Ordinary Council Meeting

27 August 2019

10.3.2	PROPOSED EIGHT MULTIPLE DWELLINGS IN A FOUR STOREY BUILDING WITH BASEMENT PARKING PLUS ROOF DECK AT LOT 203, NO.9 CALE STREET, COMO	
Attachment (a):	Development Plans	24
Attachment (b):	Site Photographs	35
Attachment (c):	Applicant Justification	37

RE: PROPOSED MULTI-DWELLING DEVELOPMENT (8 UNITS) LOT 203 (HN 9) CALE STREET, COMO

ISSUE	PLANNING APPLICATION	PROJECT	PROPOSED UNIT DEVELOPMENT	DATE	JUN 2019
DWG TITLE	LANDSCAPING PLAN	SCALE	1:100 AT A3	SCALE	1:100 AT A3
PROJECT No	180110465	DRAWN	LL	CHECKED	SPH
REV	A11	G

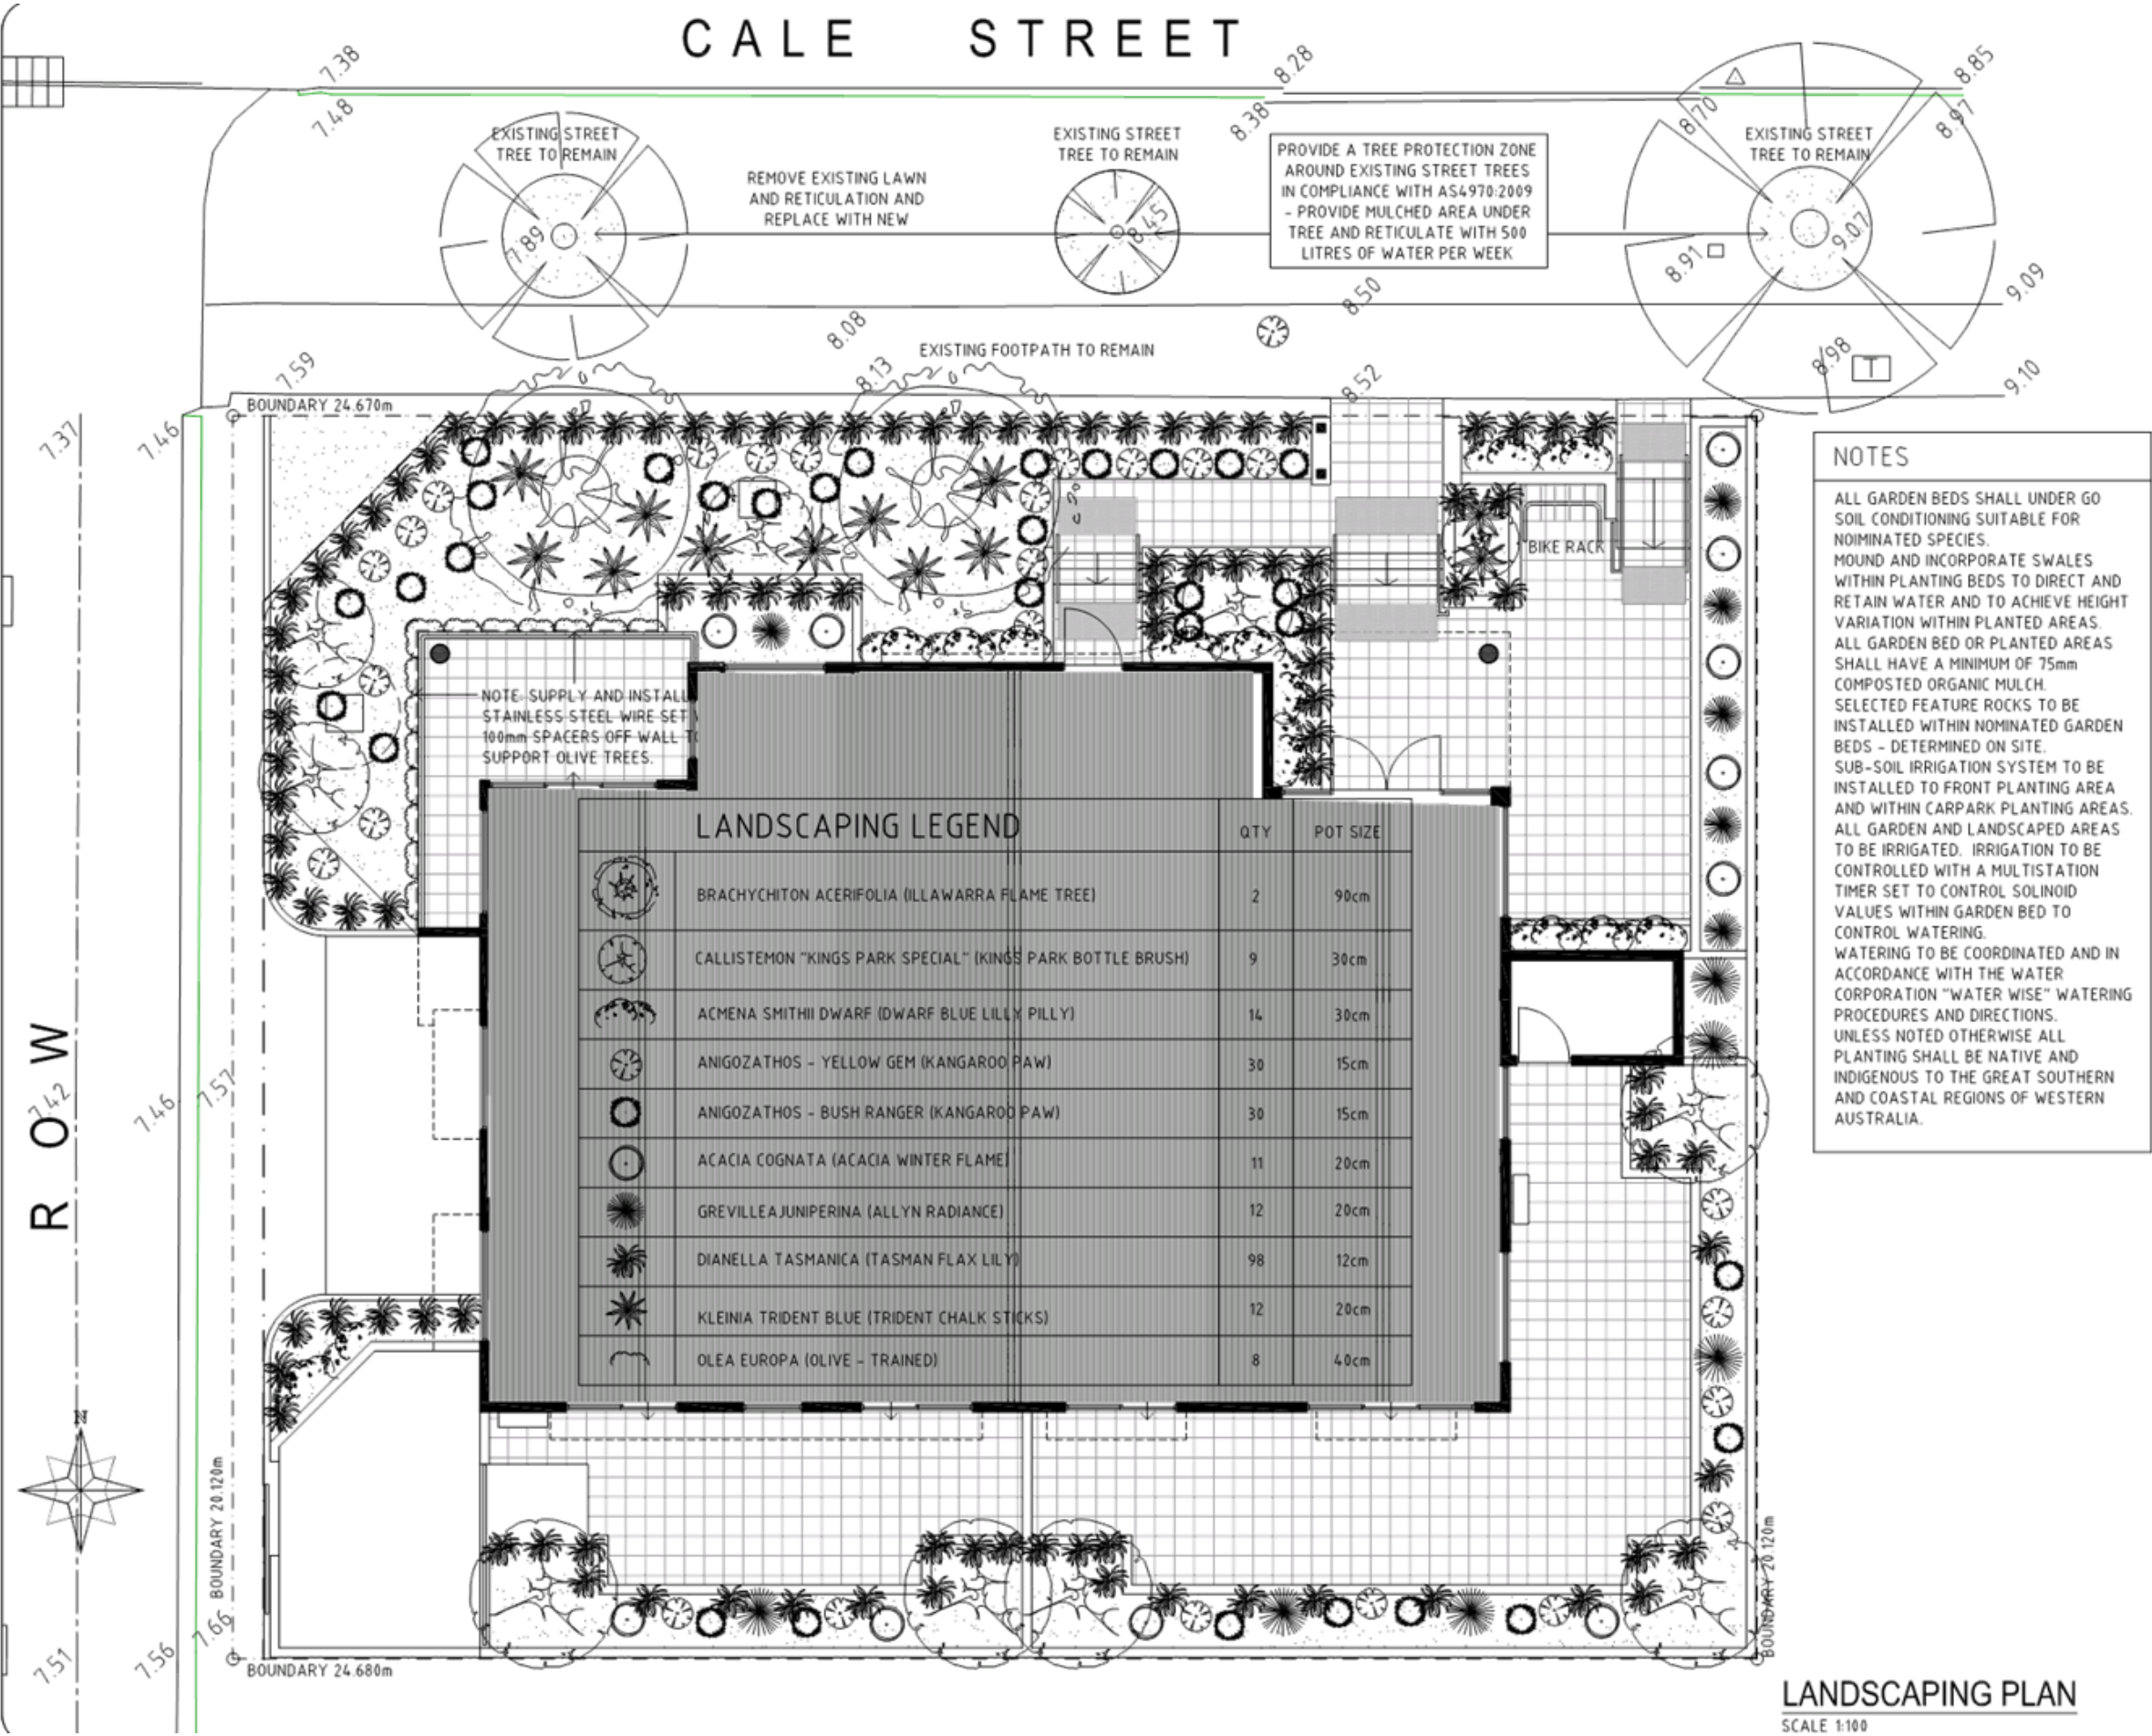
We have taken onboard the comments made by both the City's Landscape Officer and Design Review Panel and have amended our drawing and landscaping layout to address the points raised.

Street Trees: We have reviewed AS4970:2009 and acknowledge the importance of establishing a Tree Protection Zone for existing street trees. We have amended our Landscaping Plan to note that a Tree Protection Zone is to be established with Mulch and reticulation able to provide 500 litres a week to each street tree in the verge adjacent the development. We understand that the TPZ will be conditioned on the Development Approval and we look forward to liaising with the City to appropriately address this requirement

This has included providing 2 off 'significant' trees at the front of the development and modification of the nominated planting species to local varieties.

Please refer to our amended drawing A11 for details.

Please refer to our amended drawing A11 for details.

- We have amended the Landscaping plan to provide 2 larger scale trees, chosen from the City of South Perth's "Street Tree Management Plan" whereby the "Illawarra Flame Tree" was selected for its foliage, and size. We note the trees use on: Darley Street, Douglas Avenue, Kardan Circuit, and Murray Street and believe it will enhance the development and the surrounding location.

DATE		JUNE 2019		PROJECT		PROPOSED UNIT DEVELOPMENT		ISSUE		PLANNING APPLICATION	
SCALE		1:100 AT A3		DRAWN		LL		DWG TITLE		STREETSCAPE NORTH ELEVATION	
CHECKED		SPM		COMO		A10		PROJECT No		DRAWING No	
										180110465	
										REV	
										A10	
										G

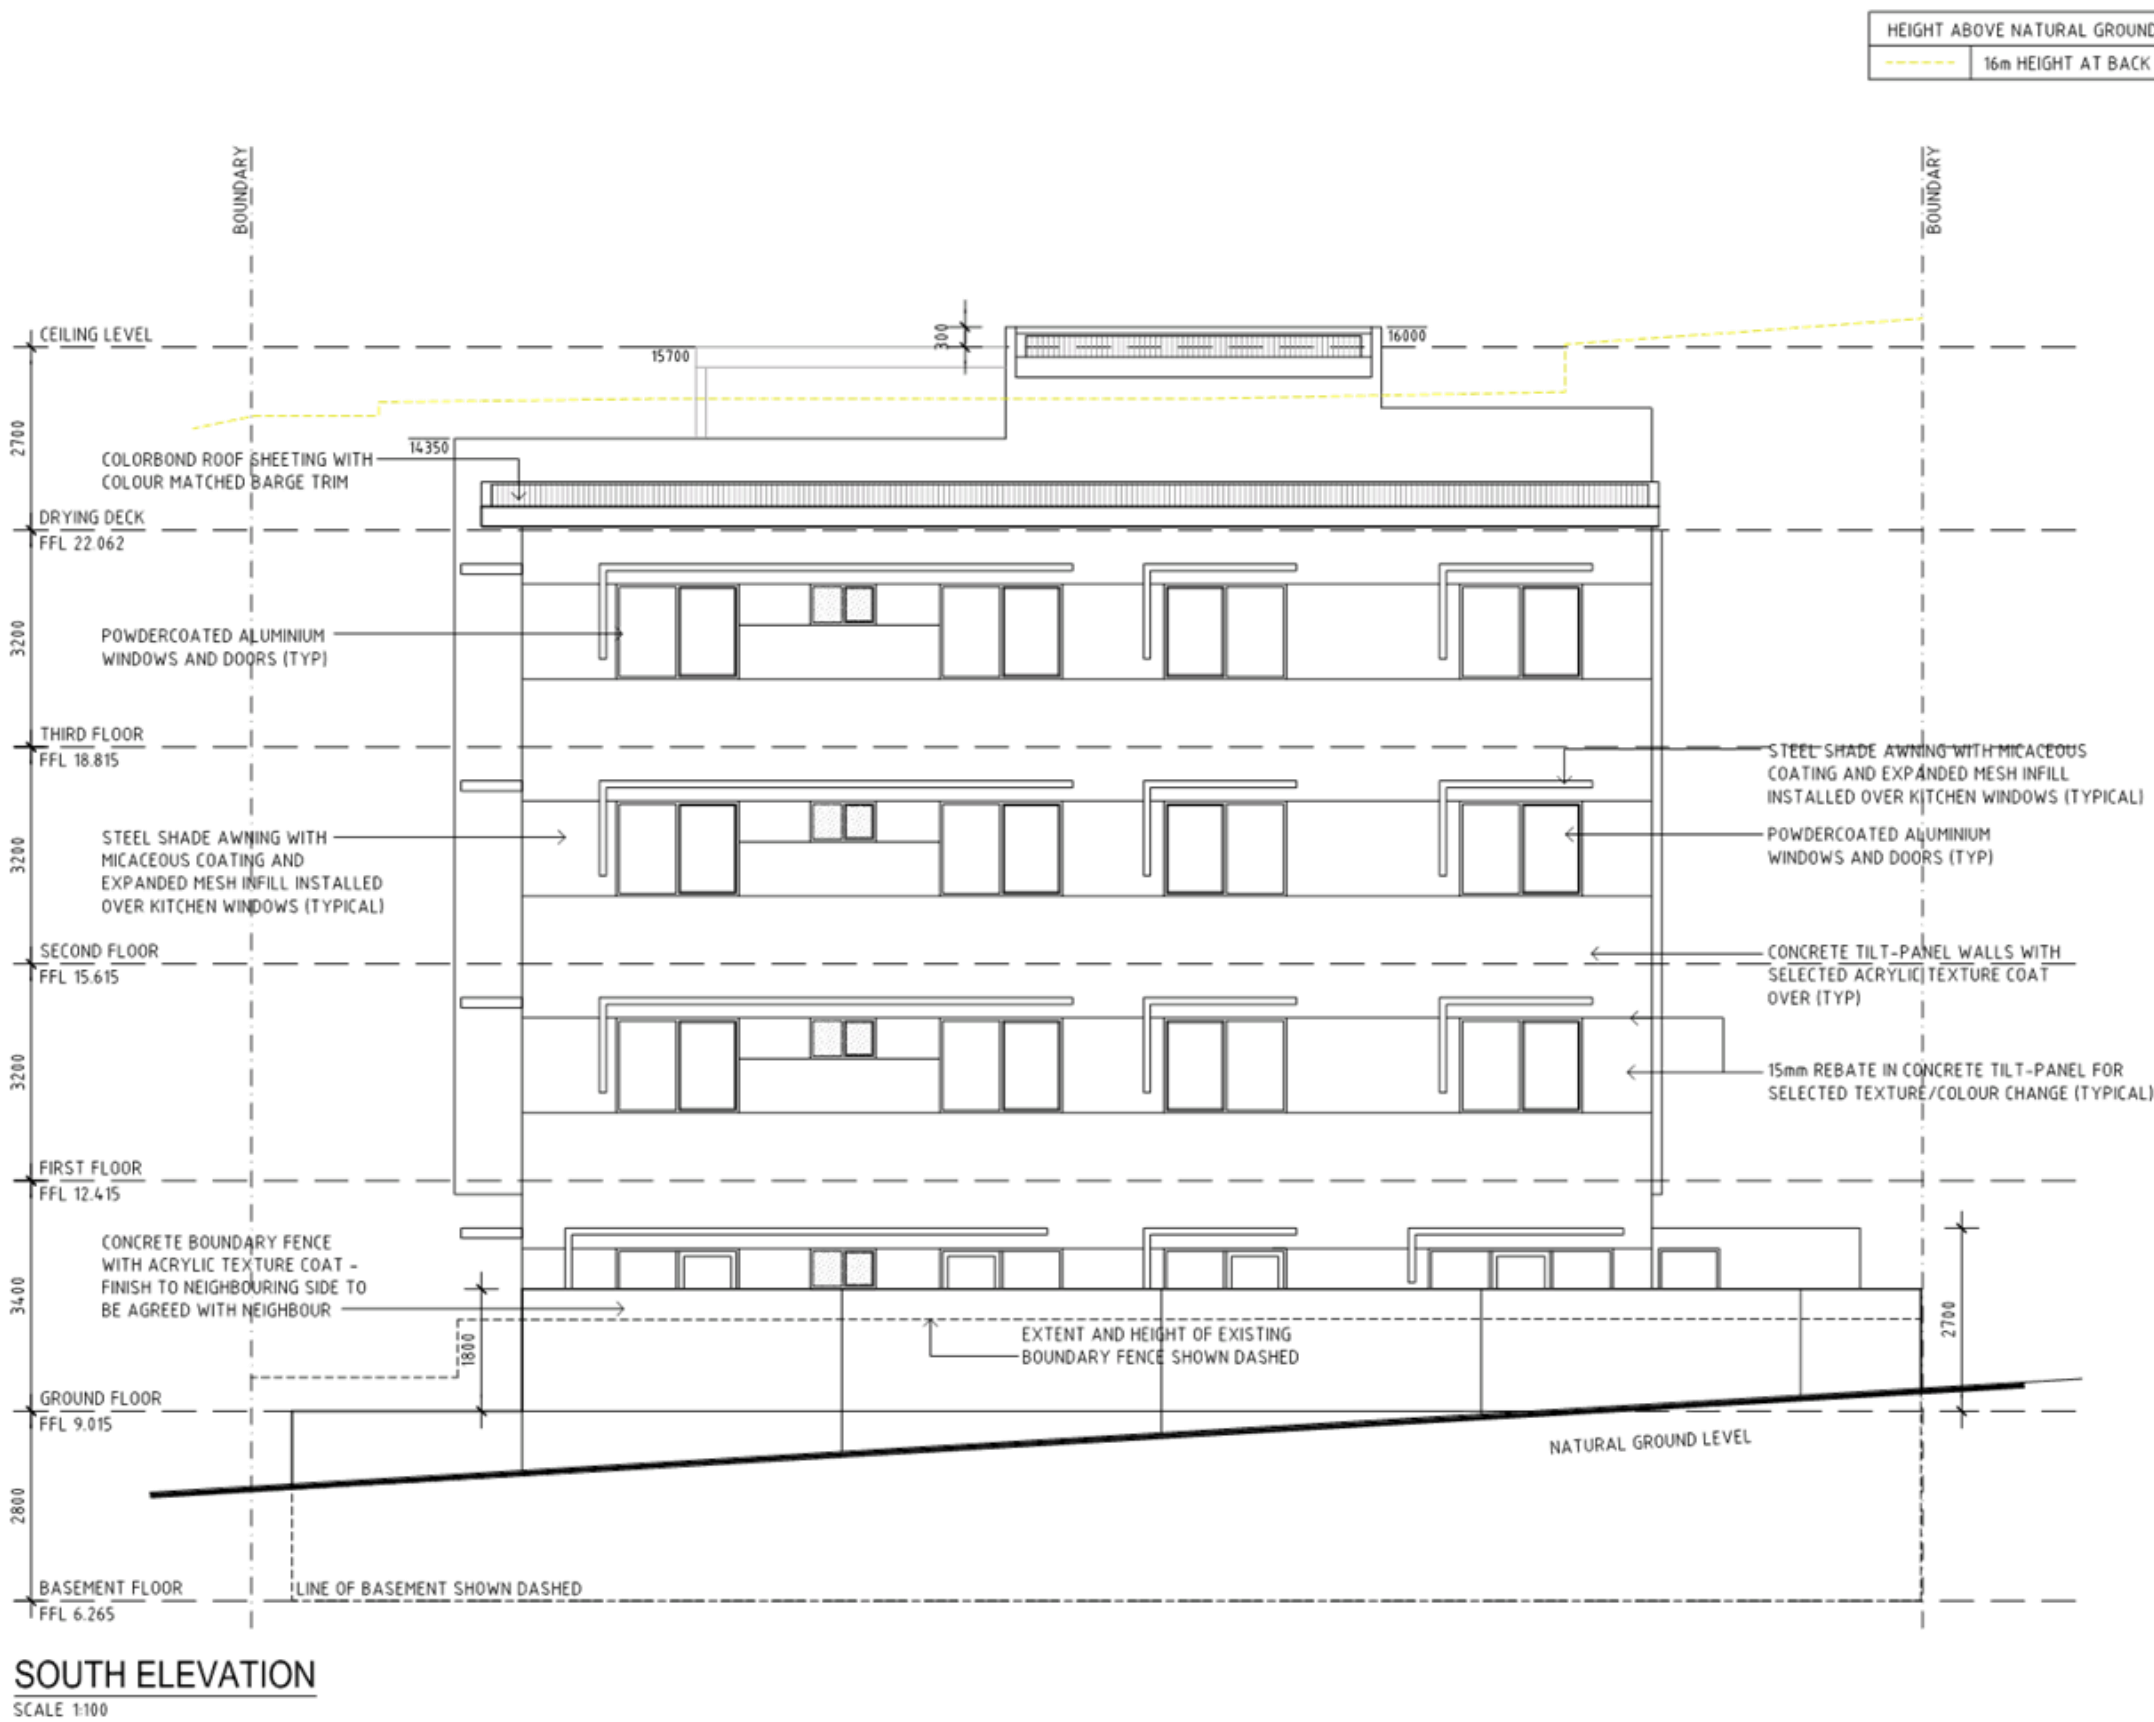
We received the Design Review Panels' comments on the 13th May 2019. We have had an opportunity to review the items identified under "Weaknesses of the Proposal" and "Suggested improvements to the Proposal" which have informed our amendments and modification of the development. We believe that the proposal has addressed each of the points raised in an appropriate and rigorous way to provide the City with a development that achieves the Desired Outcomes for not only the CBACP zone but for development generally with the Como and South Perth area.

- A significant amount of time has been devoted to reviewing the Front elevation and the surrounding context and character of the adjoining developments and wider suburb. We have amended the front elevation to simplify the elements and provide a more coherent and considered aesthetic.
